INFORMATIONAL PCN #: 2150

PCN Title: Conversion to Diodes Incorporated standard logo on BCD branded products.

PCN-2150 REV 00

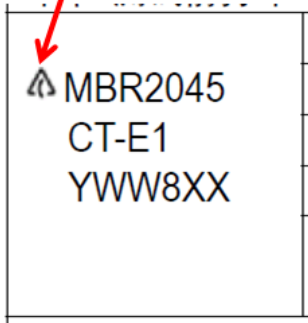
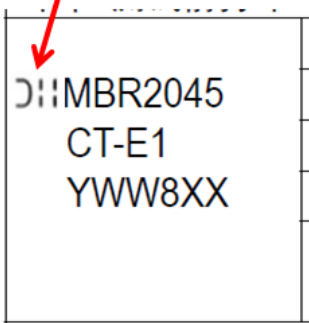
Notification Date:	Implementation Date:	Product Family:	Change Type:	PCN #:
7 th August, 2015	Immediately	Discrete/Analog Semiconductors	Part Marking	2150
TITLE				
Conversion to Diodes Incorporated standard logo on BCD branded products				
DESCRIPTION OF CHANGE				
<p>This PCN is being issued to notify customers that in order to standardize our logo symbol, Diodes Incorporated is in the process of changing from the BCD logo to the Diodes Incorporated standard logo on BCD branded products.</p> <p>Please see examples below.</p> <p>Parts currently using the BCD logo on the part marking will continue to ship until existing supply is exhausted.</p> <p>The corresponding device data sheets will be revised accordingly, as well.</p>				
From:		To:		
The BCD logo before change	The Diodes logo after change
